Cameo Communication INC.		
Title		
Name:ESX601-54RQ		
Size	Document Number	Rev
A	MAC_POWER_CorePower	1.0
Date:	Friday, June 09, 2017	Sheet 6 of 104

Name:ESX601-54RQ

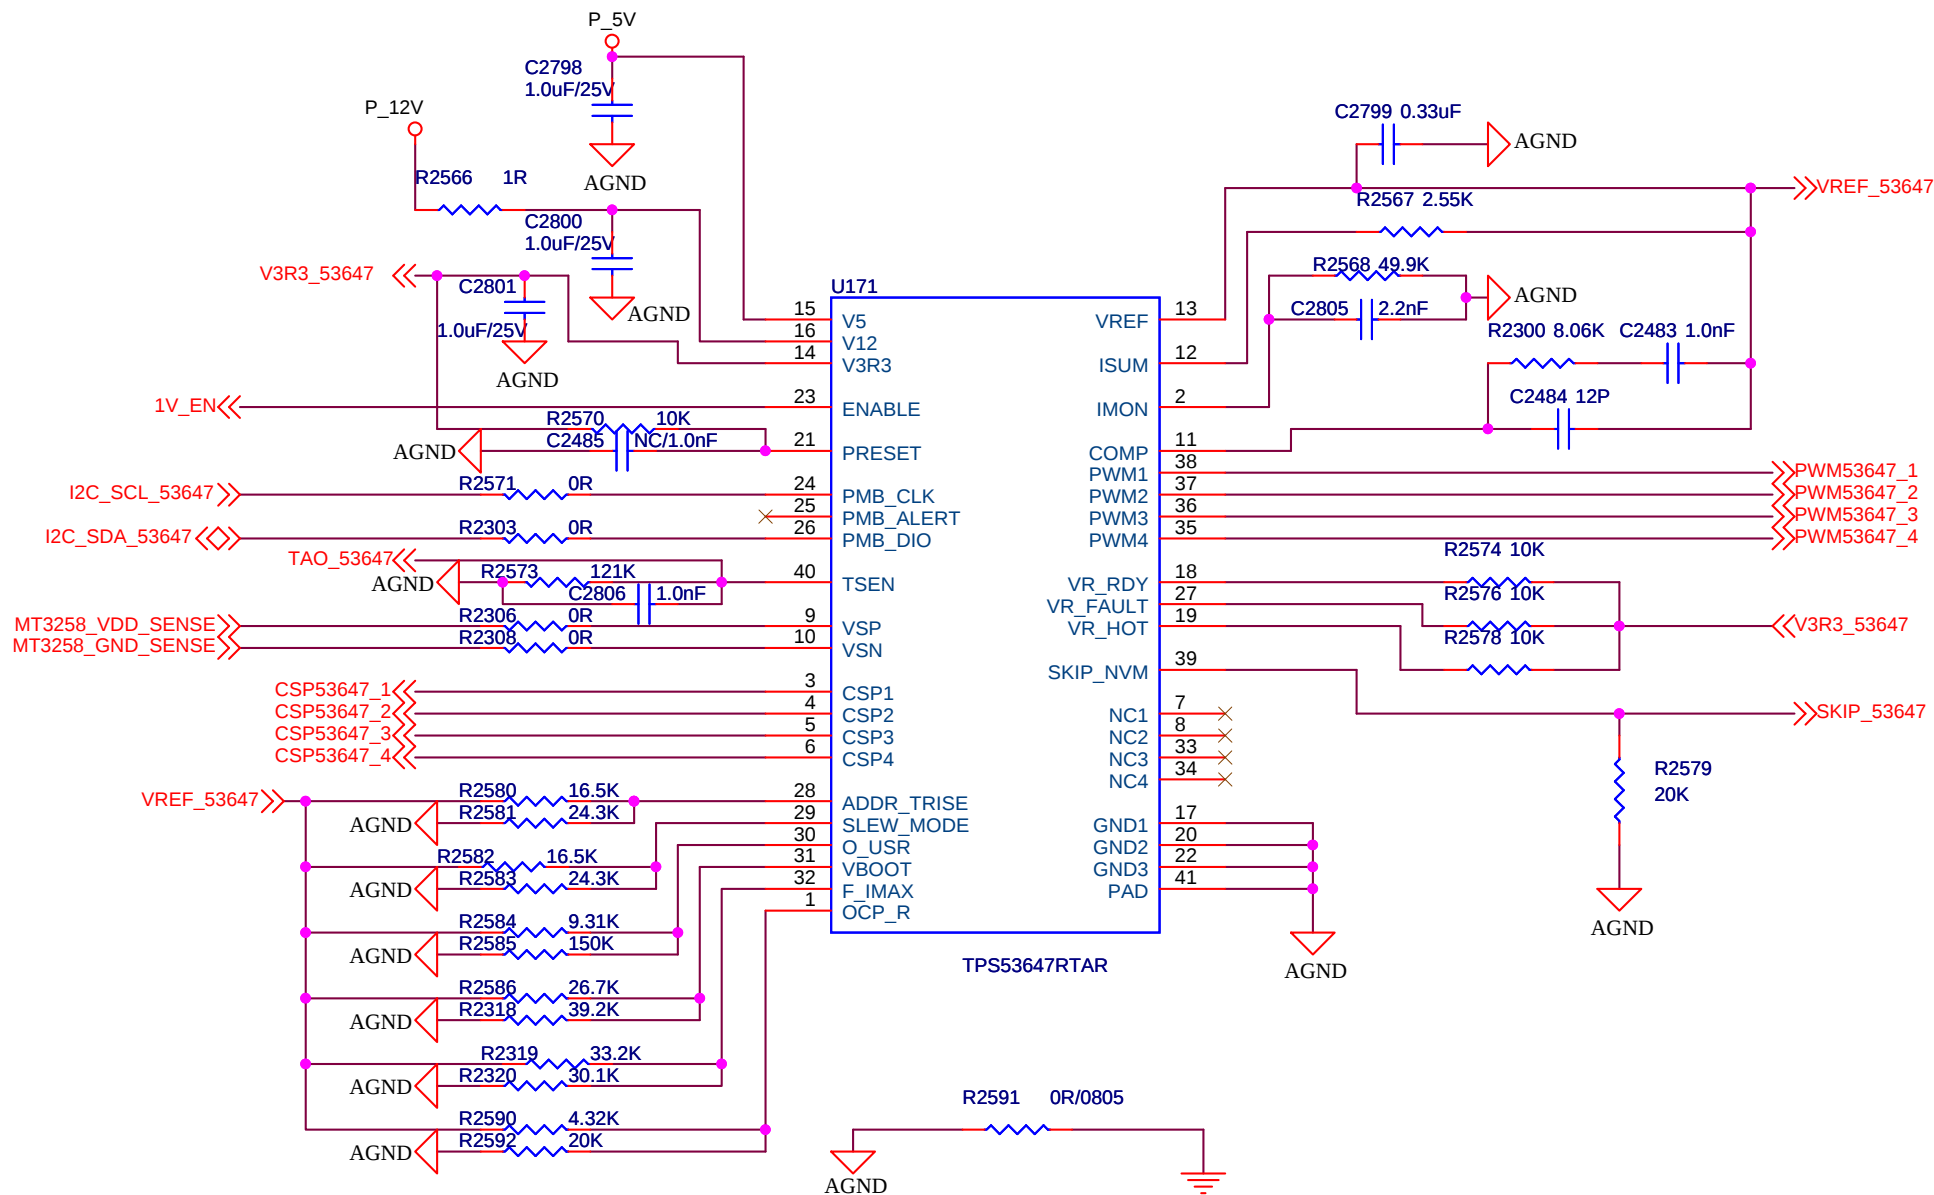
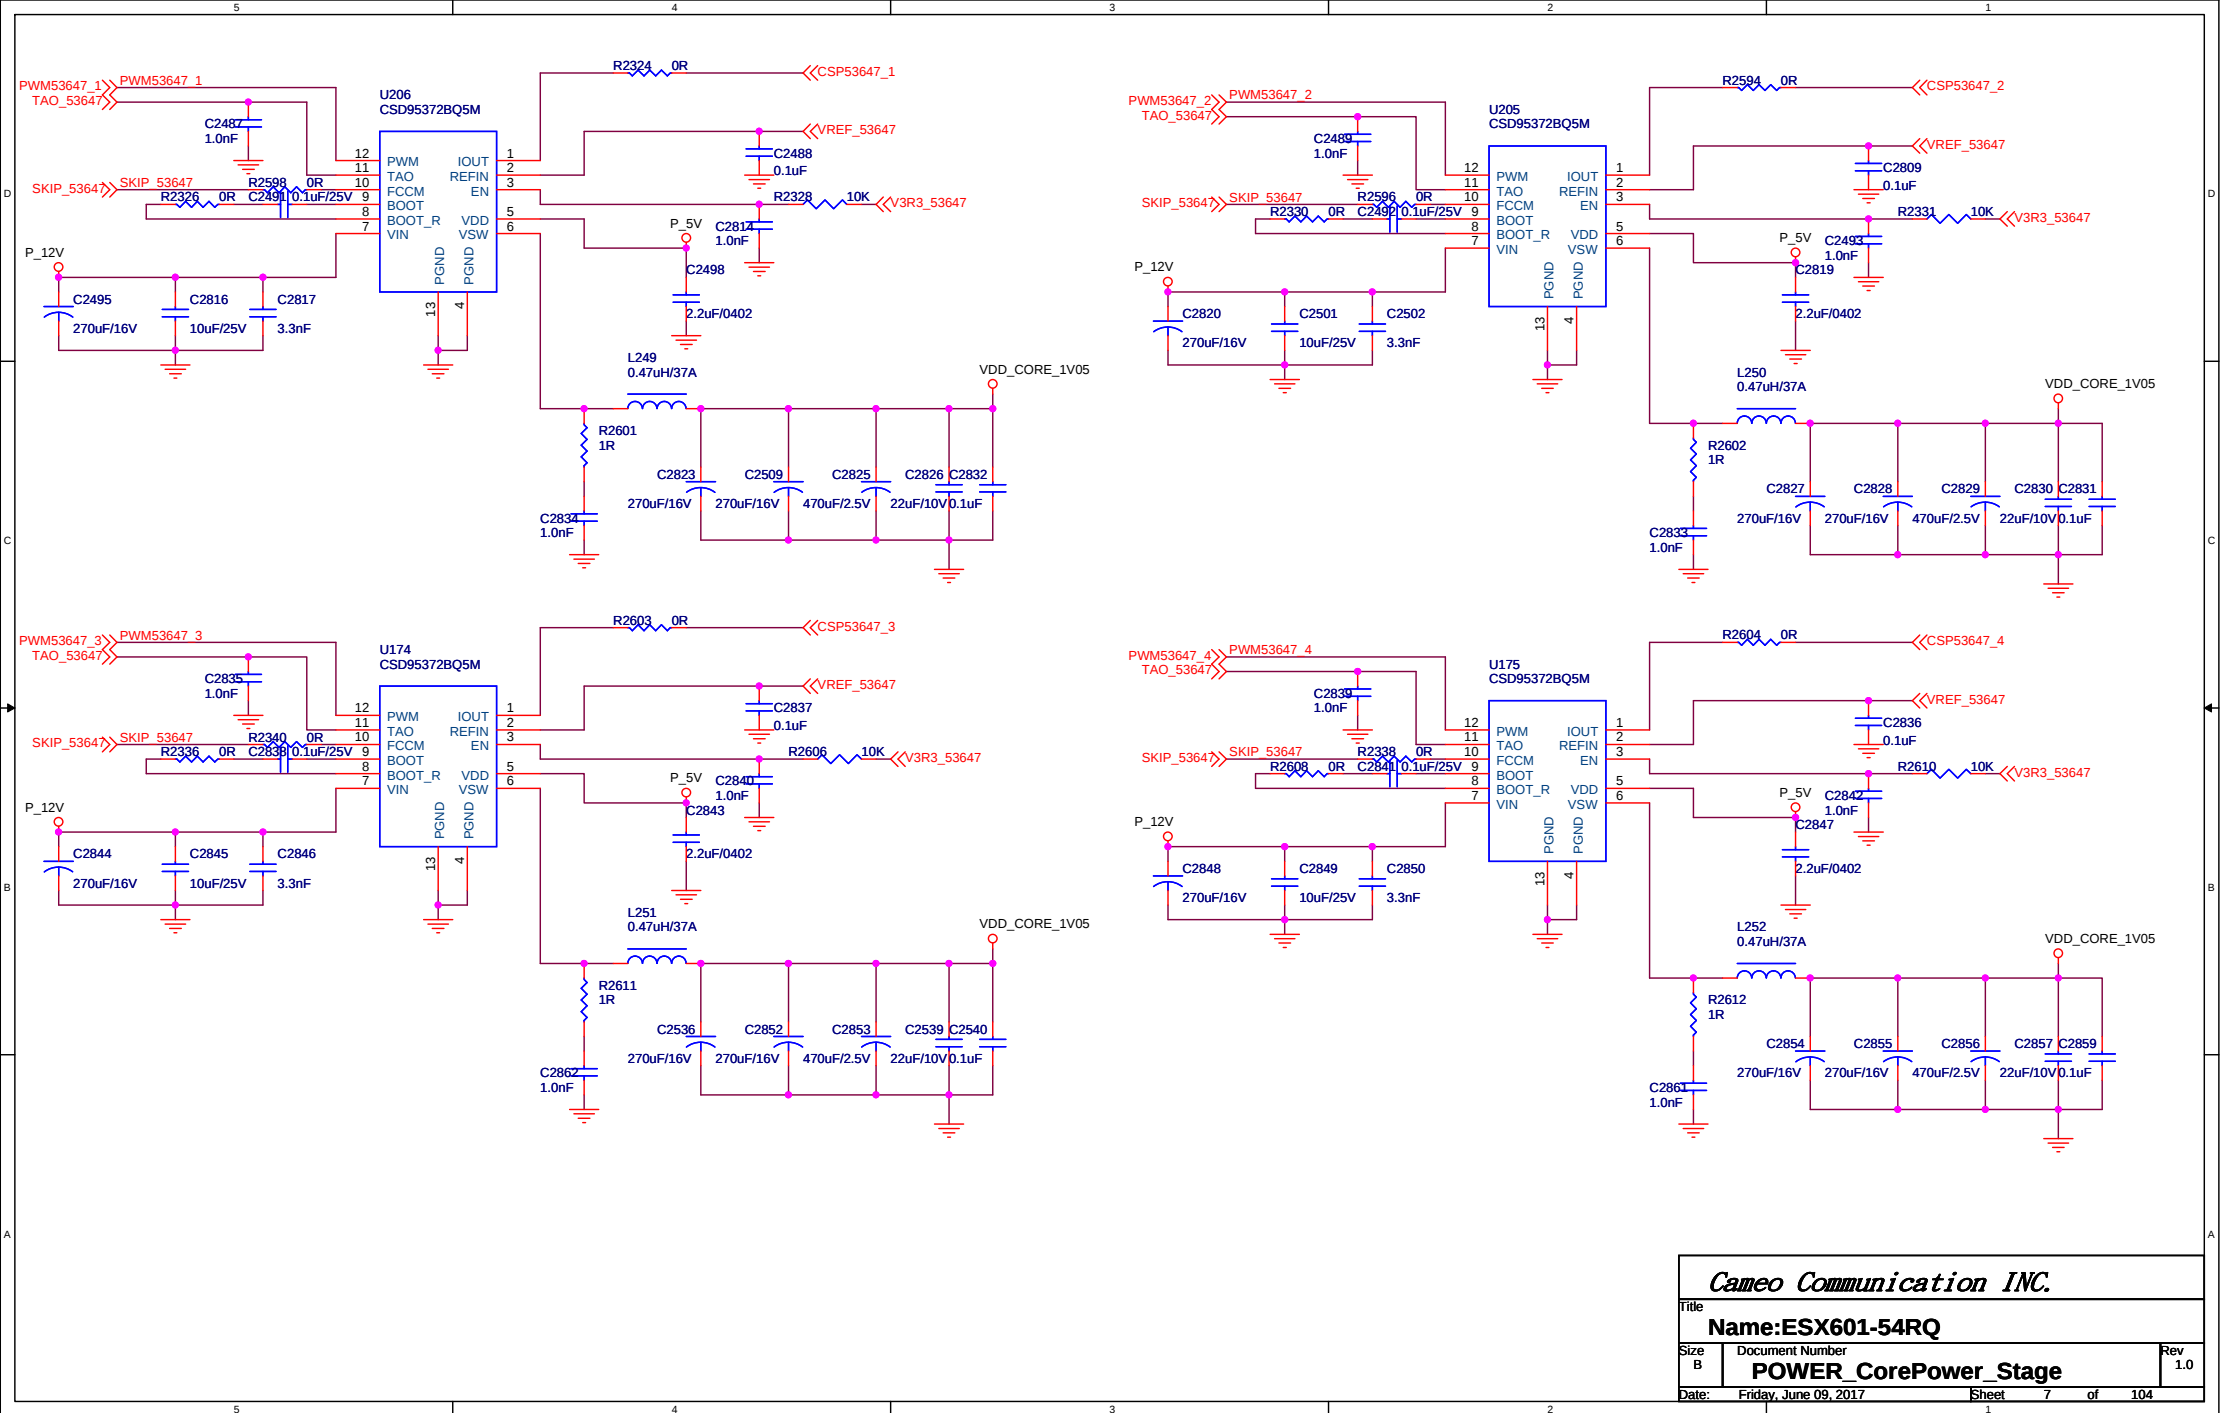
修改SS電容由3.3nF 改成0.1uF
修改OCP電阻由4.3K 改成8.2K
Enable 增加POMS 控制
